HL-5963

**Edwin I. Hatch Nuclear Plant**  
**Additional Information Related to the Staff's Review of Severe**  
**Accident Mitigation Alternatives (TAC Nos. MA8096 and MA8098)**

**OFFICE OF NUCLEAR REACTOR REGULATION  
REQUEST FOR ADDITIONAL INFORMATION (RAI)  
RELATED TO THE STAFF'S REVIEW OF  
SEVERE ACCIDENT MITIGATION ALTERNATIVES  
RELATED TO LICENSE RENEWAL FOR THE EDWIN I. HATCH NUCLEAR PLANT,  
UNITS 1 AND 2 (TAC NOS. MA8096 AND MA8098)**

Figure 1.b-1 Initiator Distribution Hatch Unit CDF

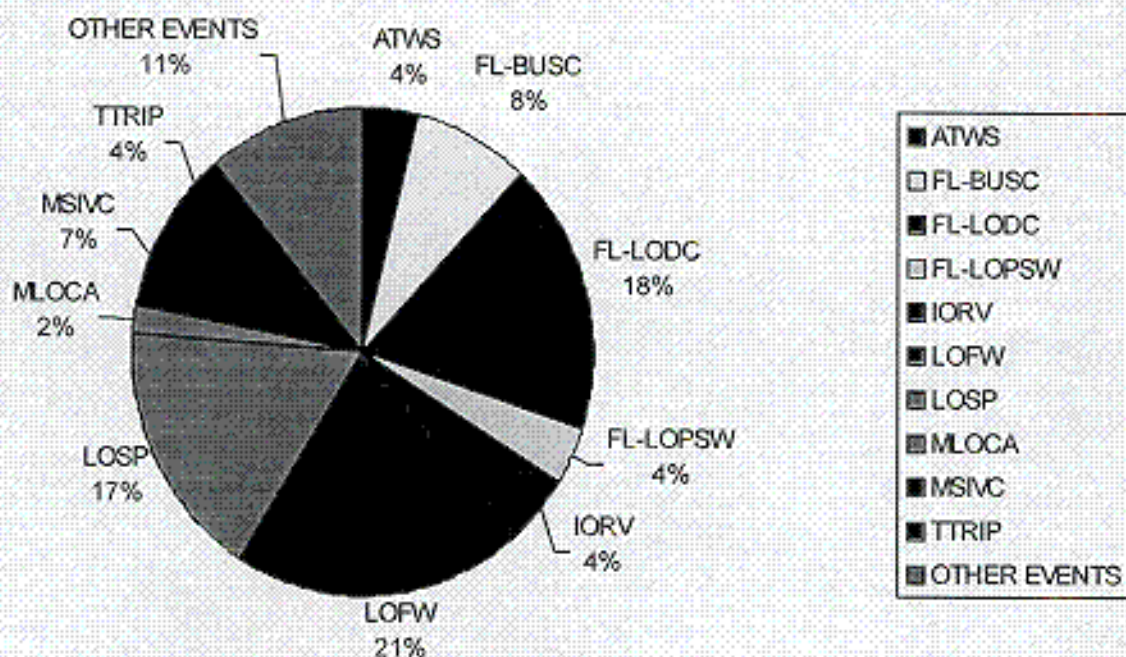
- a. **"A specific reference for the probabilistic risk assessment (PRA) study, and a description of the internal and external peer review of the Level 1, 2, and 3 portions of the study."**

The tables and pie graphs presented in figures 1.b-1 and 1.b-2 provide CDF and large early release fraction (LERF) information regarding Unit 1 major initiating events. The response to RAI question 1.e provides the insight in terms of major contributors (hardware and human failures).

**Figure 1.d-1 Hatch Containment Event Tree**

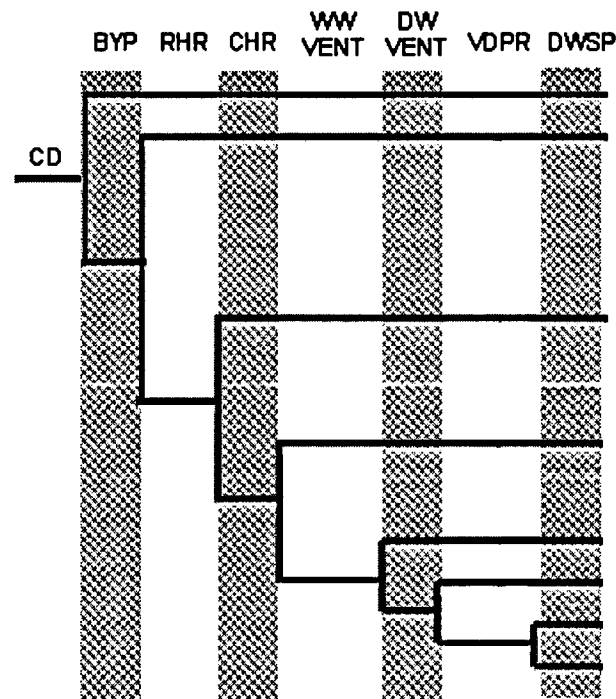
- c. **"A listing of the dominant Level 1 accident sequences including the sequence logic in terms of event tree top events, and a mapping of these sequences to the Level 2 release categories. Provide sufficient supporting material to allow an outside PRA reviewer to understand the sequences and mappings."**

The LERF model is based on a CET developed by Fauske and Associates (see Hatch Containment Event Tree, figure 1.d-1). This tree was used to construct the LERF model for the Hatch PSA. Details of this construction are described in Attachment 2 with Attachment 1 describing the core damage model interface. Comparison of this tree to the IPE version shows a great simplification. Due to the direction of the nuclear PSA industry and the NRC, only large early releases were considered. The Hatch definition of LERF is as follows: A rapid, unscrubbed release of airborne aerosols within 6 hours of the time between vessel failure and containment failure. In
